Service Bulletin

Product Family: Ariens and Gravely 915- and 991-Series Mowers

Subject: Kohler KT Smart Choke™ Engines Hard Starting / Rich Running

KT Series Smart-Choke™ Rich Running/Hard Starting Conditions

Figure 1. Governed Idle Speed Adjustment.

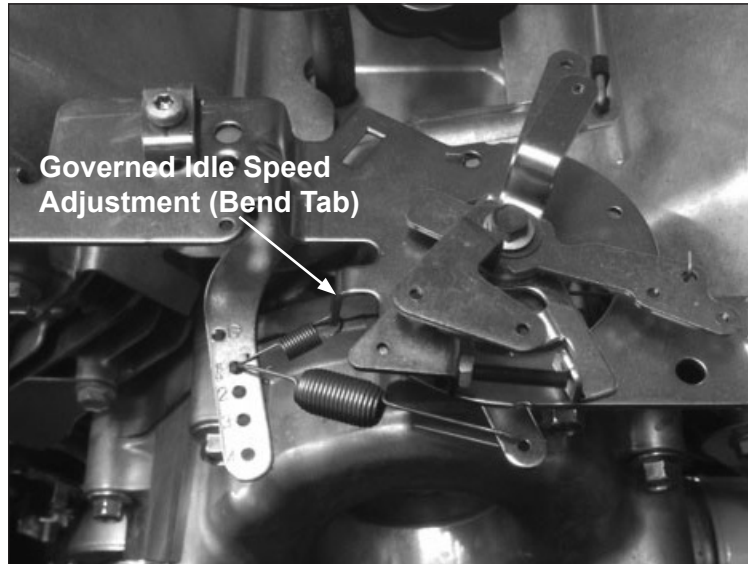
- Engine Starts “Rich”, (blubbers), DOES NOT “clean-out” and continues to run “Rich”:
 - 1) Start unit at “FULL” throttle.
 - 2) Run unit for 5 minutes to fully warm up and clean out excess fuel.
 - 3) Recheck the GOVERNED IDLE SPEED and if necessary reset to 1750-1800 RPM. (See Figure 1.)
 - 4) Restart and recheck operation.

Figure 2. Choke Link 32 079 08-S and Air Vane Detail. (Air Cleaner Assembly Removed for Clarity.)

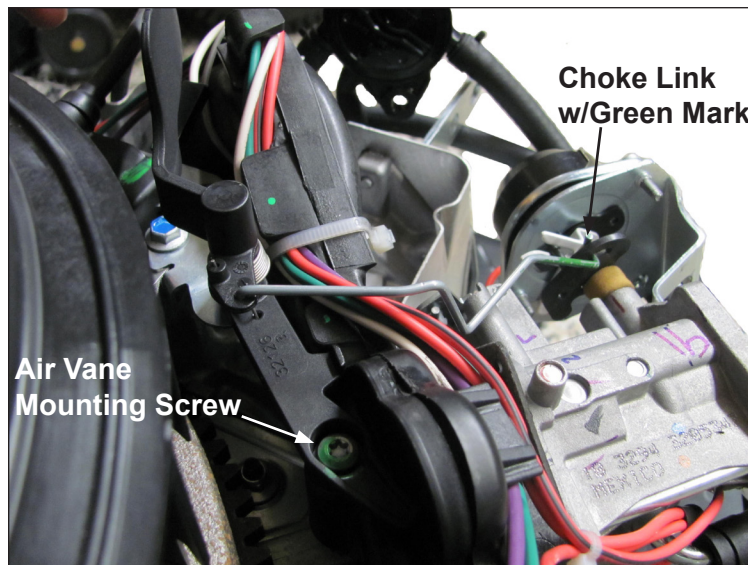
- Engine Starts “Rich”, (blubbers):
 - 1) Check that no physical binding of linkage or the choke exists.
 - 2) If no binding is found, replace the Choke Unloader Link with Part Number 32 079 08-S *(See NOTE below).
 - 3) Restart and recheck operation.

*NOTE: The 32 079 08-S choke link is identified by a “Green” paint mark and is slightly (0.067”) shorter. Implemented as running change and is already contained on many units. (See Figure 2.)
